REQUEST FOR PROPOSAL

Addendum # 9

RFP Title: On-Board Systems / Communication Center System

RFP Number: 04-001PR

Figure 1.C.7.3. Level 1 Architecture

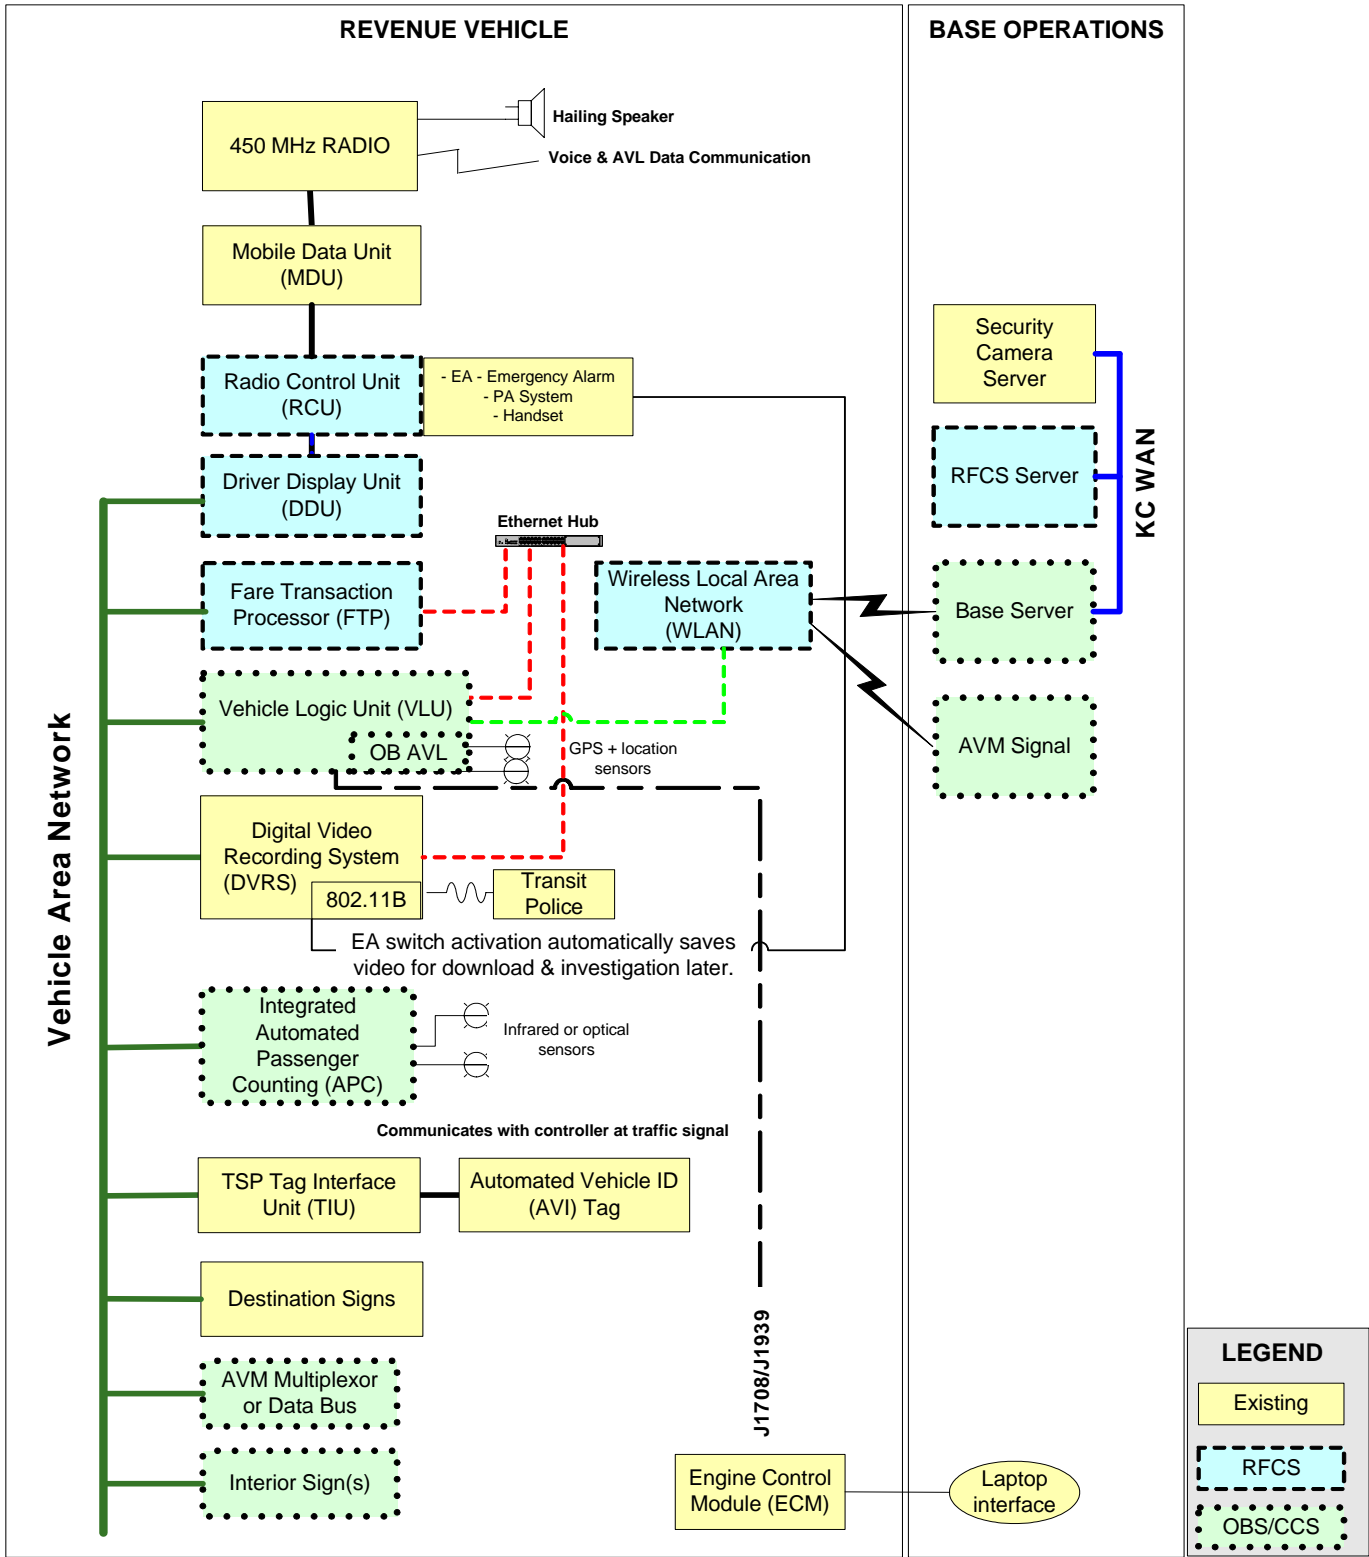
Part C, SECTION 1 OBS/CCS Business Requirements			
4.	Subsection C.1.C.7.3 Figure 1.C.7.3. Level 1 Architecture	RFP modifications required by the specified ERG-provided on-board architecture detailed in Part C, Appendix P.	<p>CLARIFICATION:</p> <p>The on-board architecture to be provided by ERG has the OBS/CCS VLU directly connected to the WLAN for both the Level 1 (FIM) and Level 2 OBS/CCS implementation. The VLU contractor will be required to provide a seamless update to the DDU shared memory to enable the OBFTP and DDU devices to communicate. Additionally, it must assist in routing the traffic between certain devices (OBFTP, DDU and DVRS) and the WLAN.</p> <p>See Addendum 6, Answer 6; and Addendum 7, Attachment One, Appendix P, <i>RFCS Project Equipment & Systems Architecture Including the DDU, WDOLS & OBFTP</i>.</p> <p>DELETE:</p> <p>Figure 1.C.7.3. Level 1 Architecture</p> <p>REPLACE WITH:</p> <p>New Figure 1.C.7.3. Level 1 Architecture shown below in ATTACHMENT TWO</p>

ATTACHMENT TWO: replacement figure for insertion into Part C as Figure 1.C.7.3. Level 1 Architecture (see Answer 4 above).

Figure 1.C.7.4. Level 2 & TRS Architecture

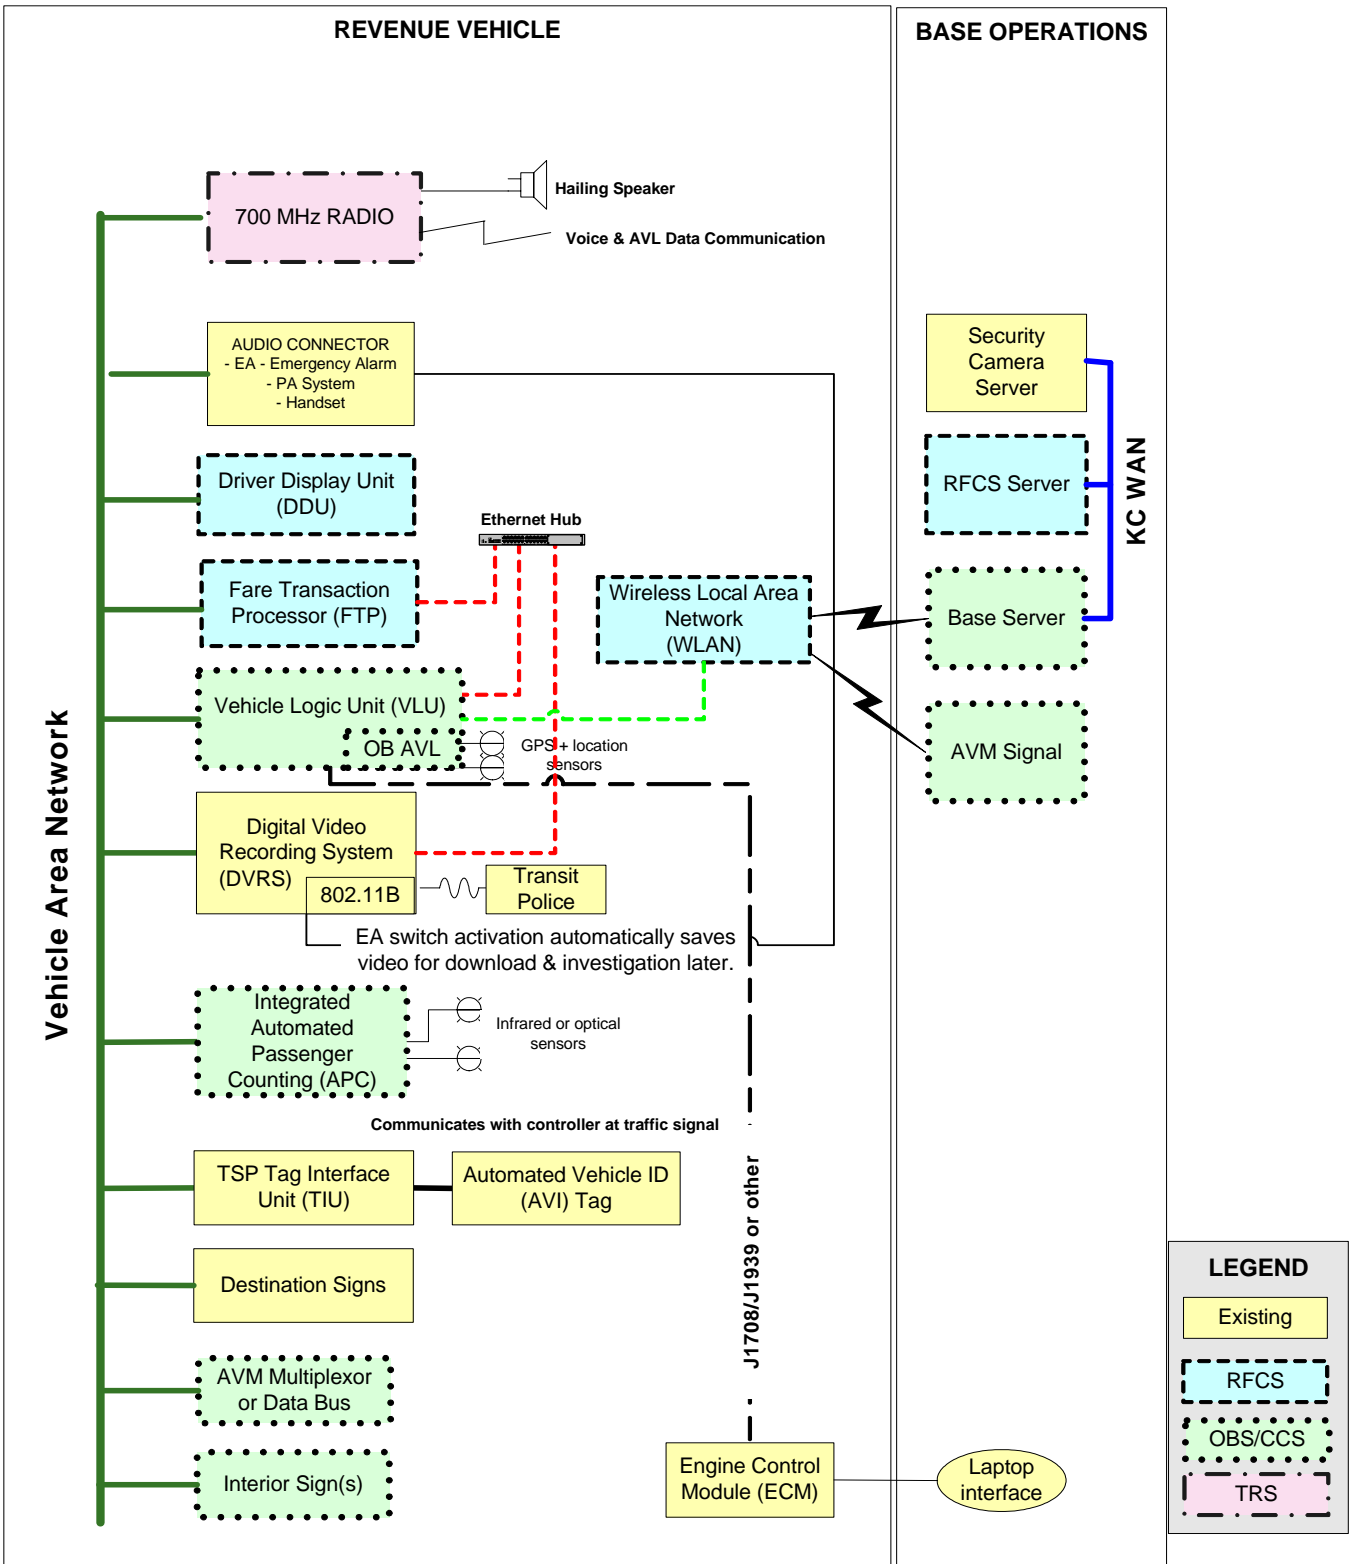
5.	Subsection C.1.C.7.4, Figure 1.C.7.4. Level 2 & TRS Architecture	RFP modifications required by the specified ERG-provided on-board architecture detailed in Part C, Appendix P.	<p>CLARIFICATION:</p> <p>See Answer 4 above.</p> <p>DELETE:</p> <p>Figure 1.C.7.4. Level 2 & TRS Architecture</p> <p>REPLACE WITH:</p> <p>New Figure 1.C.7.4. Level 2 & TRS Architecture shown below in ATTACHMENT THREE</p>

ATTACHMENT THREE: replacement figure for insertion into Part C as Figure 1.C.7.4. *Level 2 & TRS Architecture* (see Answer 5 above).
